PD 1223

**Re: Administrative Relief request for Waterway Business Planned Development No. 1223
Parking reduction for Talman Soccer at 3626-3714 N. Talman Avenue**

RE: **Planned Development No. 1223, Proposed signage for Chicago Near North Soccer**

Sheet No: **SP11**

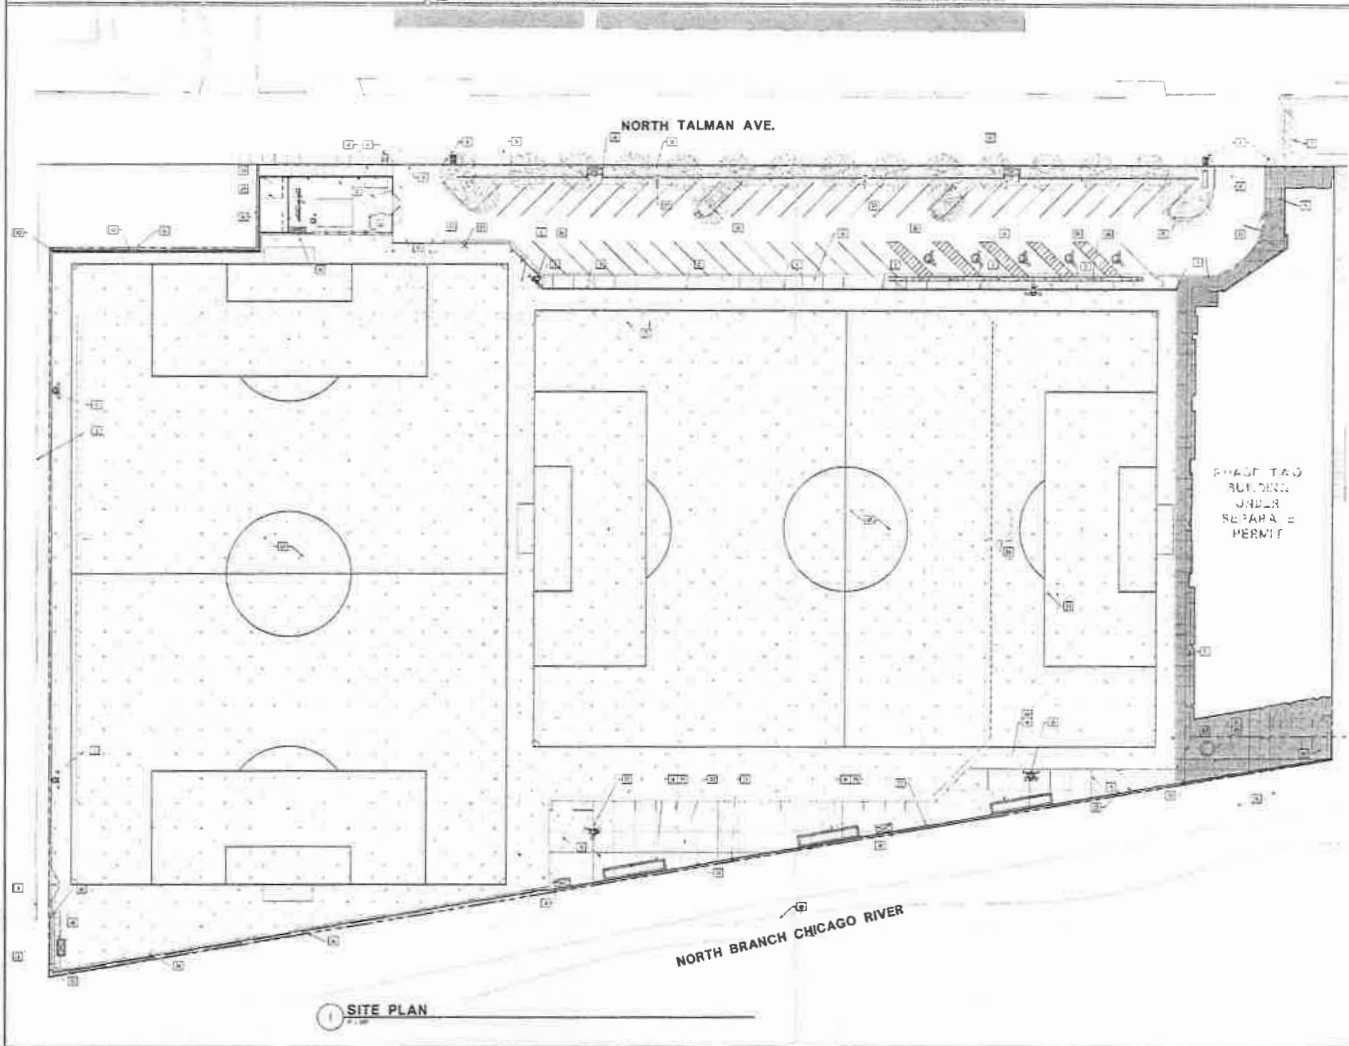
Your client and the sole owner of all of the property within PD 1223, Talman Soccer LLC, is seeking administrative relief for a reduction in the minimum number of required parking spaces from 52 spaces to 50 spaces for the soccer facility at 3626-3714 N. Talman Ave. A larger mechanical space than what was originally proposed is required for the soccer facility and this has resulted in the elimination of two parking spaces. The attached, revised Site Plan, dated May 21, 2014, shall be inserted into the main file.

With regard to your request, the Department of Planning and Development has determined that allowing the proposed parking reduction from 52 to 50 spaces will not create an adverse impact on the Planned Development or surrounding neighborhood, will not result in an increase in the bulk or density, and will not change the character of the development, and therefore, would constitute a minor change.

Accordingly, pursuant to the authority granted by the Chicago Zoning Ordinance and Waterway Business Planned Development No. 1223, I hereby approve the foregoing minor change, but no other changes to this Planned Development. This minor change is valid for twelve (12) months from the date of this letter unless action to implement the minor change is commenced within such time period and thereafter diligently pursued to completion, including, if applicable, construction consistent with the minor change as authorized by a building permit. If action to implement the minor change, including construction, does not begin within the time set forth, or does not proceed with reasonable diligence, then the approval will lapse and become null and void.

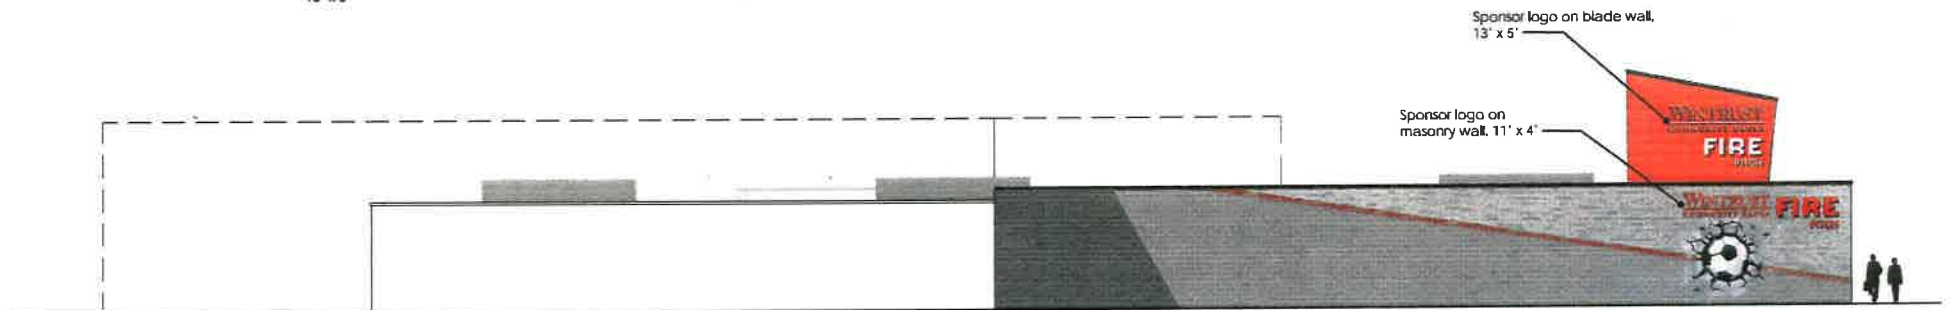
We have reviewed the attached sign proposal for the Chicago Fire Soccer Center. While we appreciate their efforts in reducing the amount of signage proposed, we cannot approve 8,139 square feet of total signage. Based on an underlying manufacturing zoning district, Planned Development Number 1223 is permitted 5 x the street frontage (518.29 feet) or 2,591 square feet of total sign area.

The proposed painted signs on the turf will be covered by a dome during part of the year and not legible from the public way. Therefore, they do not require sign permits and are not counted in the total square footage allowed on the site.

However, pursuant to Statement Number 6 of the Planned Development, off-premise signs are prohibited. Sponsorship signs are considered off-premise signs. Therefore, unless the official name of the facility will be the Chicago Fire Wintrust Community Bank Soccer Center, the Wintrust Community Bank portion of the proposed signage is considered sponsorship, or off-premise signage, and is not allowed. Also, pursuant to Section 17-12-1003 of the Chicago Zoning Ordinance, the maximum wall sign area cannot exceed 33% of the building wall area. The proposed signage on the seasonal tent link appears to cover the entire wall area and will need to be reduced to 33% or less.

Finally, video display signs are prohibited except in a Planned Development in which the principal use is a sports stadium or convention center. This facility is considered an entertainment and spectator sport establishment and not a sports stadium. Therefore, the proposed video sign is not allowed. If you have any questions or require further information, please contact Teresa McLaughlin of my staff at (312) 744-3509.
